Subject: Final Report - DER 84-51  
A 50.55(e) Reportable Condition Relating To Failure Of The  
Turbine-Driven Auxiliary Feedwater Pump To Quick Start From  
Ambient Conditions.  
File: 84-019-026; D.4.33.2

FINAL REPORT - DER 84-51  
DEFICIENCY EVALUATION 50.55(e)  
ARIZONA PUBLIC SERVICE COMPANY (APS)  
PVNGS UNITS 1, 2, 3

SKETCH FOR DER 84-51

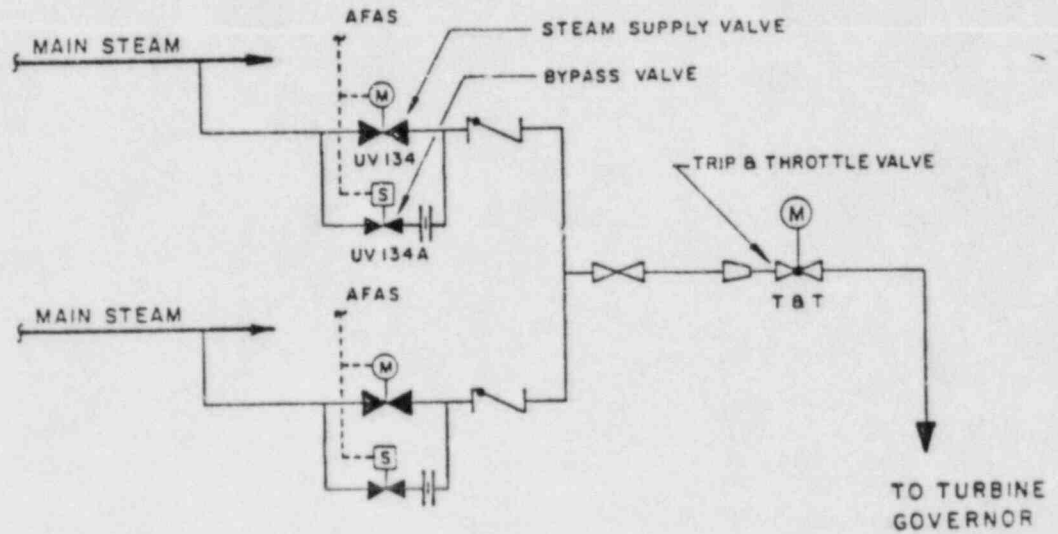
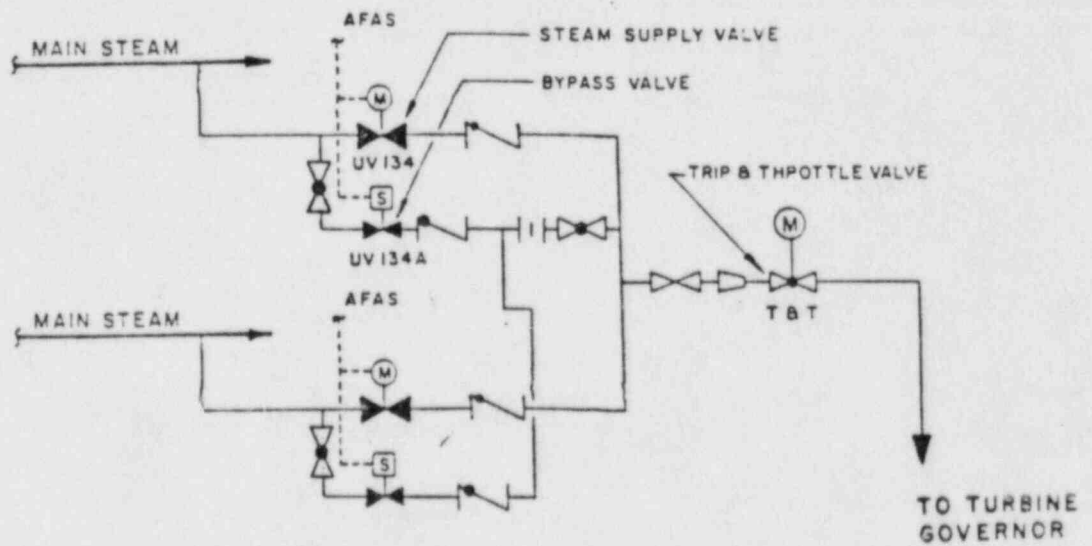
During an emergency shutdown condition, following the initiation of an AFAS, the steam supply valves receive a signal to open in order to start the steam turbine. Upon receipt of an AFAS signal, the solenoid-operated bypass valves open to bring the turbine up to idle speed prior to full steam admission. An adjustable Agastat relay provides a time delay prior to opening the supply valves. In the original design the idle speed was set at 1300 rpm and the steam supply valves opened five seconds after the solenoid bypass valves received a signal to open.

Evaluations have indicated that the five-second delay is not sufficient to allow for the warming up of the lines and pump casing and attain the turbine idle speed. Since the turbine speed control system maintains the governor valve in a full open position until the idle speed is reached, the start of main steam admission within five seconds after the initiation of a turbine startup command results in the entry of "ungoverned" steam flow to the turbine causing an overspeed condition and consequently the rapid closure of the trip and throttle valve.

1. The 5-second delay time has been changed to 10 seconds.
2. The discharge piping from the two solenoid bypass valves has been routed to a single orifice with an injection point closer to the turbine. This modification allows the sizing of a single orifice rather than two parallel orifices, as well as reducing the mass of pipe requiring heating before the turbine reaches idle speed. One orifice assures the same bypass steam flow to the turbine with one AFAS signal or two AFAS signals which corresponds to one steam admission valve or both steam admission valves opening.

3. The idle speed was reduced from 1300 rpm to 800 rpm.
4. The governor ramp start has been delayed until the steam admission valves are full open. In the original design, the ramp began as soon as the admission valves came off their seat.

Design Change Package (DCP) No. 1SM-AF-077 has been issued and implemented on Unit 1 to make the changes listed under Section II, Items 1 through 4. Units 2 and 3 will be modified per DCP Nos. 2SM-AF-077 and 3CM-AF-077 respectively.
